ACCESSION NBR: 8707010205 DOC. DATE: 87/06/25 NOTARIZED: NO DOCKET #
 FACIL: 50-315 Donald C. Cook Nuclear Power Plant, Unit 1, Indiana & 05000315
 50-316 Donald C. Cook Nuclear Power Plant, Unit 2, Indiana & 05000316
 AUTH. NAME AUTHOR AFFILIATION
 ALEXICH, M. P. Indiana & Michigan Electric Co.
 RECIP. NAME RECIPIENT AFFILIATION
 Document Control Branch (Document Control Desk)

SUBJECT: Provides addl response to NRC 860924 ltr requesting
 schedules for addressing plant-specific design features of
 ATWS mitigation sys actuation circuitry. Requests preliminary
 indication of acceptability of util program by 870801.

Donald C. Cook Nuclear Plant Unit Nos. 1 and 2
Docket Nos. 50-315 and 50-316
License Nos. DPR-58 and DPR-74
GENERIC LETTER 83-28, 10 CFR 50.62, AMSAC

ATTACHMENT 2 TO AEP:NRC:0838Z
PRELIMINARY AMSAC DESIGN FOR D. C. COOK PLANT

Figure 1

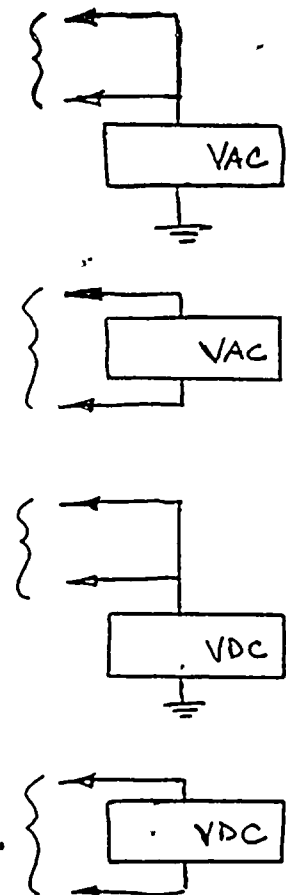
- c. Data to verify that the maximum credible fault was applied to the output of the device in the transverse mode (between signal and return) and other faults were considered (i.e., open and short circuits).

Response: Figure 1 indicates that the maximum credible faults will be applied to the output of the I/I in the transverse mode. Other possible faults (open and short circuits) are also depicted.
